REFERENCE:	Nova Bus Manuals
SECTION:	01: Structure
RS N°:	MQR 7621-1030
EFFECTIVE IN PROD.:	L961 (2016MA)

SUBJECT:	Right wall structure with 1:6 ramp
JUSTIFICATION:	Vertical beam might crack above front door, second post capping.

Figure 1 - Possible Crack Location

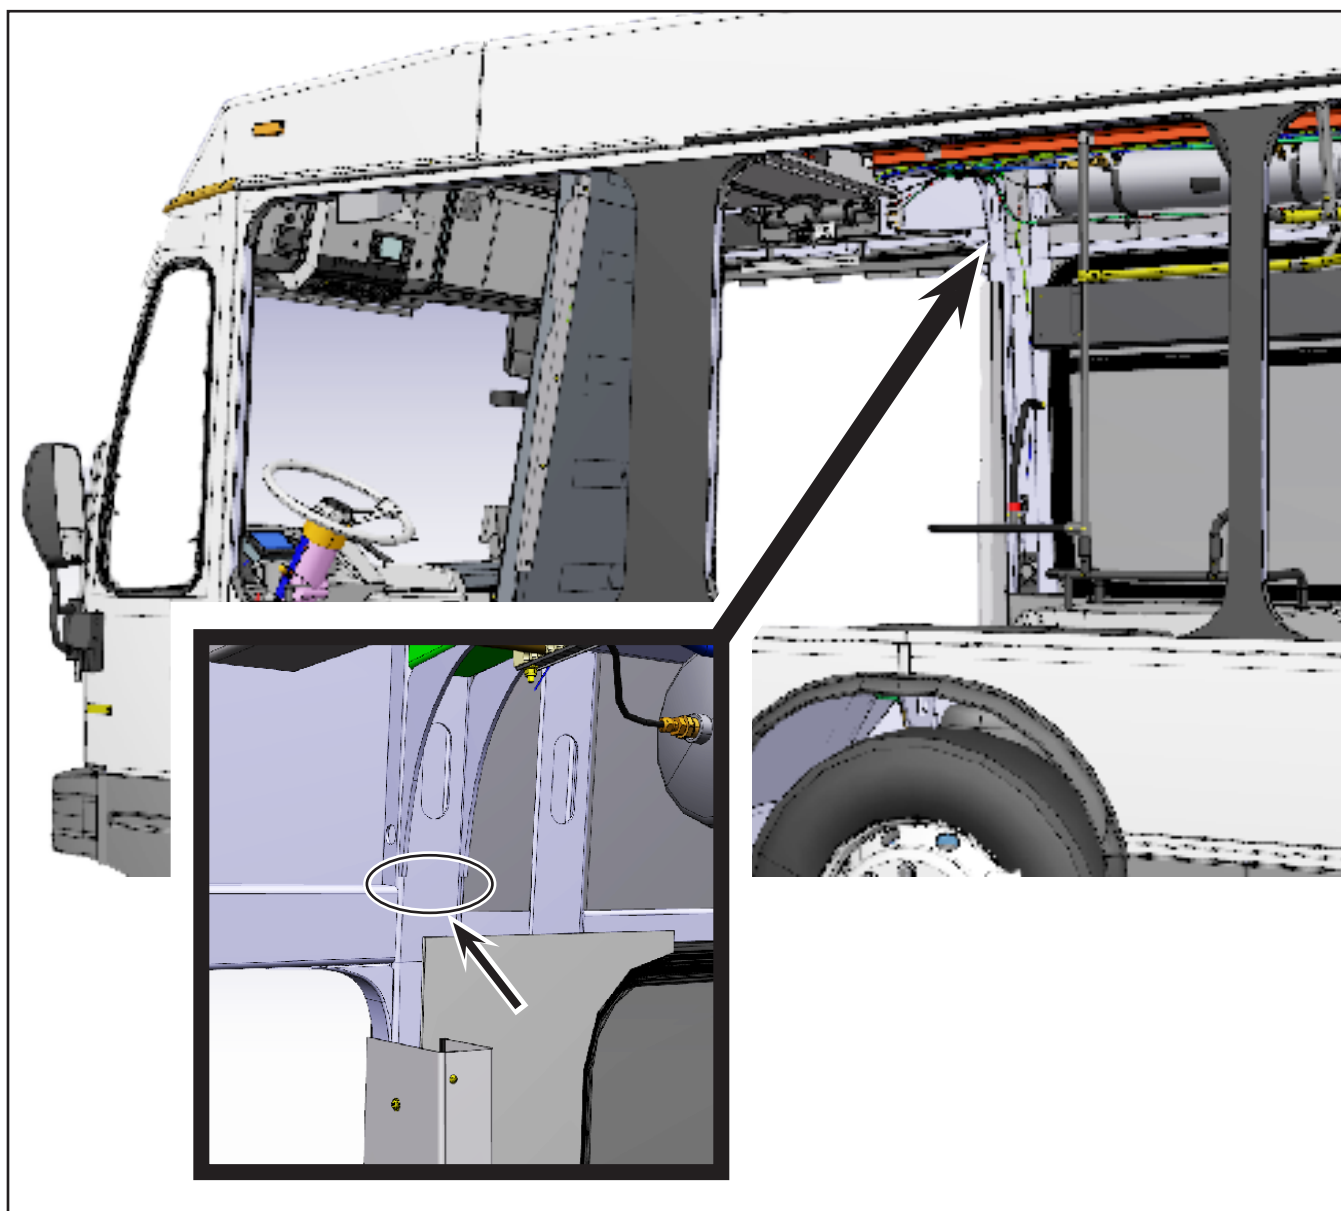
- 1.17. Inspect the area shown in Figure 1. If a crack is found, make 1/8 in. stop holes at one or both ends if possible.

Figure 8 - Surface Preparation Area

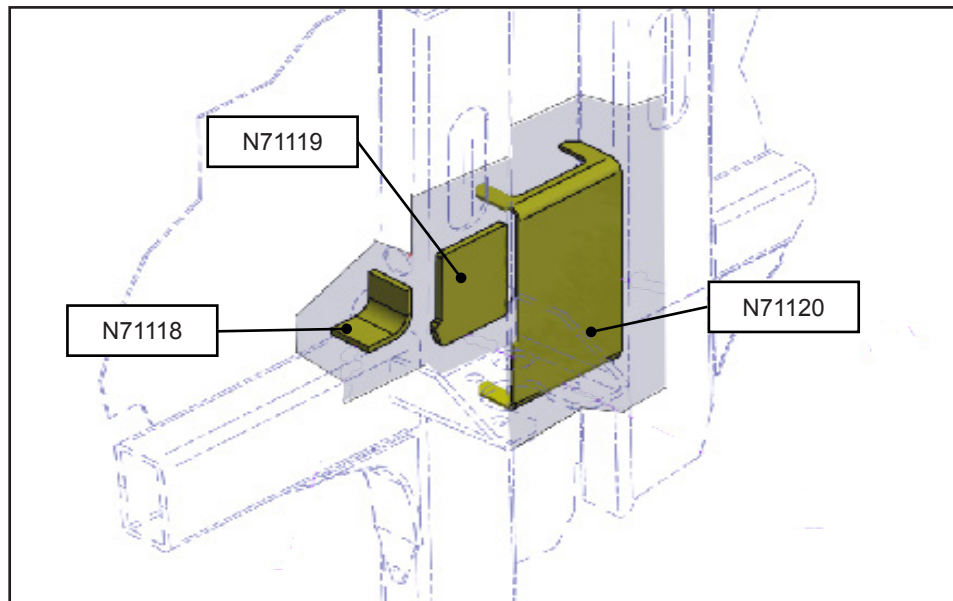
- 1.18. With a cut-off wheel, remove the original stiffener plate between the two vertical tubes, see Figure 7. This plate will be replaced by N71120, see Figure 8.

- 1.19. Surface preparation is very important. Grind as required to get smooth flat surfaces without wobbles. Remove existing welding spatters. The area to prepare has to be approximately 2 in. wider than the area covered by the new stiffening plates. See shaded area in Figure 8 for preparation area to be covered.

Figure 10 - Examples of Weld Beads that May Need to be Ground (Not Limited to These)

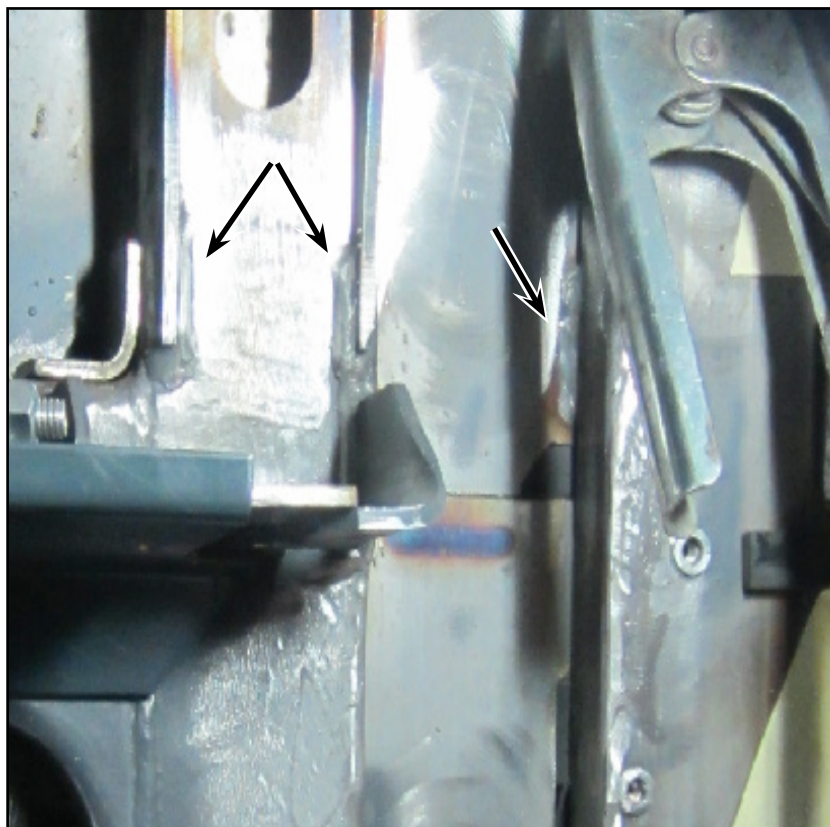
- 1.21. If there are existing protruding bumps greater than 1/16 in. from the existing weld beads, grind them flush with the weld bead. The weld on the existing structure should not be more than 1/2 inch, if it is, it should be ground down to insure that the maximum of 1/2 inch is respected. The minimum weld size to respect shall remain equivalent to the thickness of the plate being welded and respecting a maximum weld size of a 1/4 inch. See Figures 10 and 11

Figure 12 - Plates position

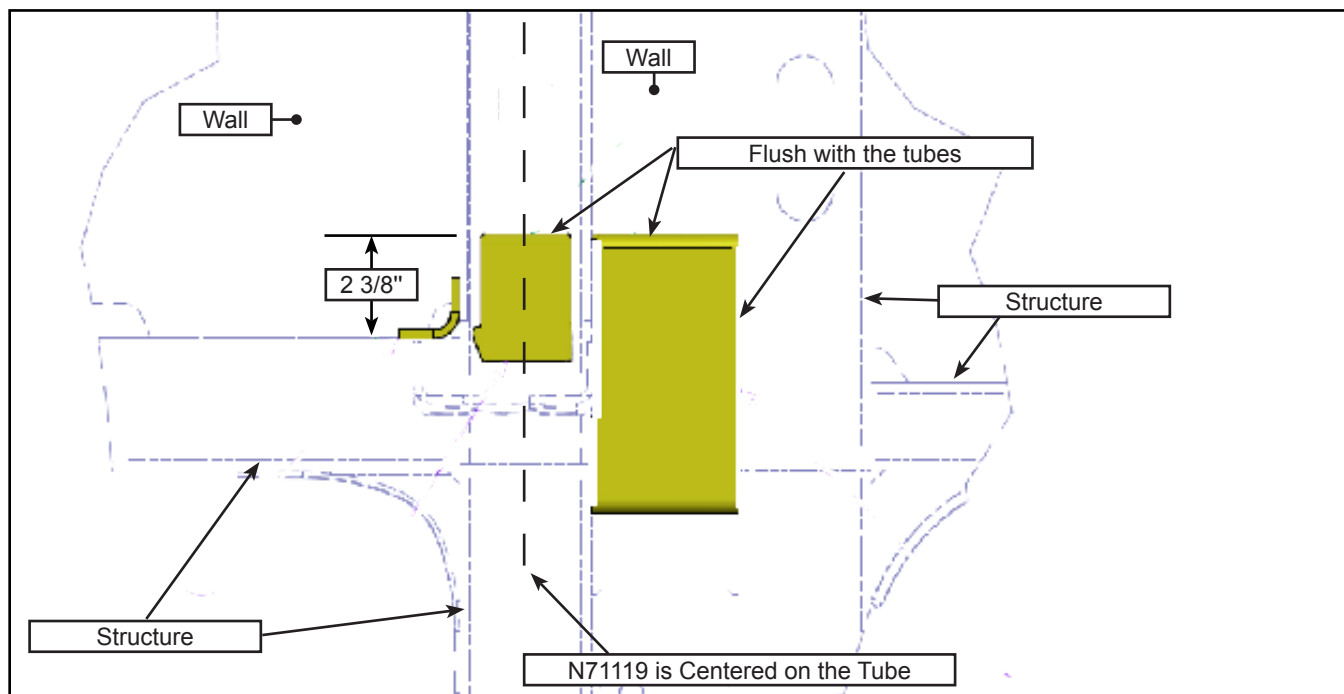
- 1.22. Verify the plates position prior to welding. See Figure 12. It may be required to grind or modify the parts.

- 1.23. A 1/8 in. gap is required between N71119 and the existing weld on the structure, grind if necessary. Press fit is not acceptable. See Figures 10 and 13.

Figure 14 - Weld the Parts in Place

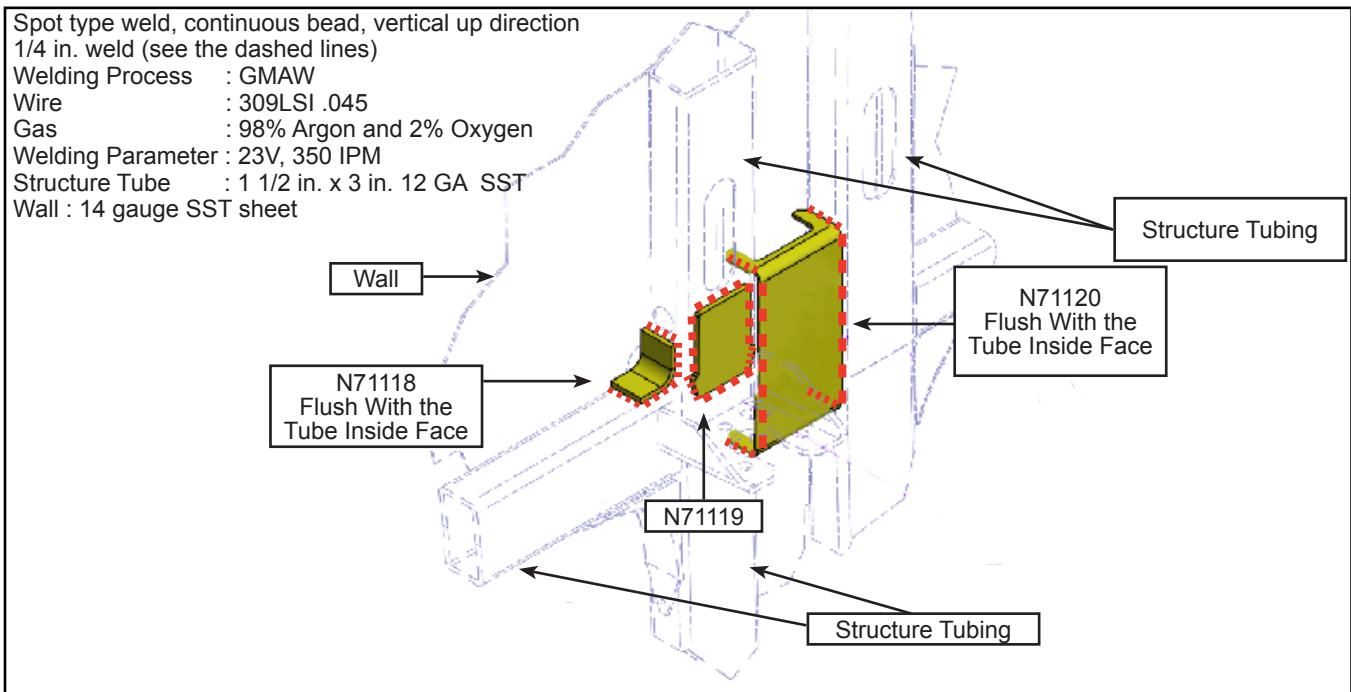
- 1.24. Plate N71119 must be centered with the vertical tube. N71118 and N71120 must be flush with the inside face of the tubes. Make a full weld on every edge, represented by the dashed lines in Figure 14. Weld to the structure tubes only, not to the wall.

Figure 15 - Fill the Gap for N71118

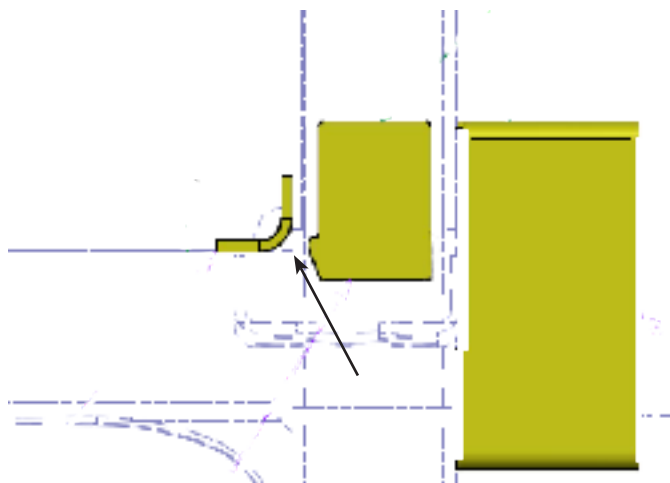
- 1.25. Fill the corner gap between the structure and N71118. See Figure 15.

Figure 16 - New Ground Location

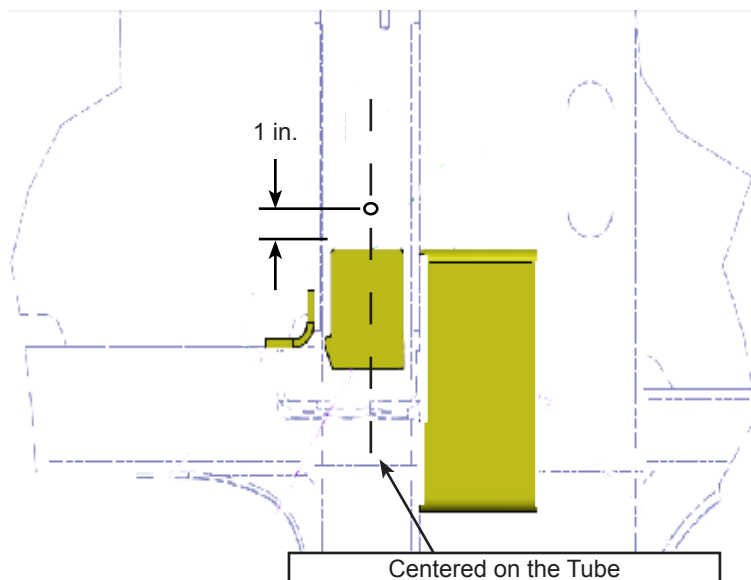
- 1.26. Make tack welds on the head of bolt N24104 to replace the previously cut ground stud. See Figures 16 and 17. The position shall be approximately 1 in. above the plate N71119 and centered on the tube. The tack welds should be on alternate corners of head bolt. This gives a total of 3 tack welds. During the tack weld operation the dimension from opposite corners should not be reduced by more than 20%.

Figure 17 - Tack Weld the Bolt

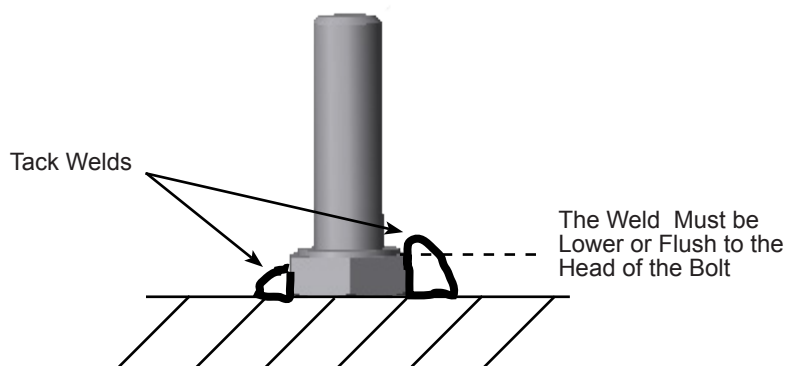
- 1.27. If the tack welds are higher than the head of the bolt, grind them flush to allow for a proper ground contact. See Figure 17.
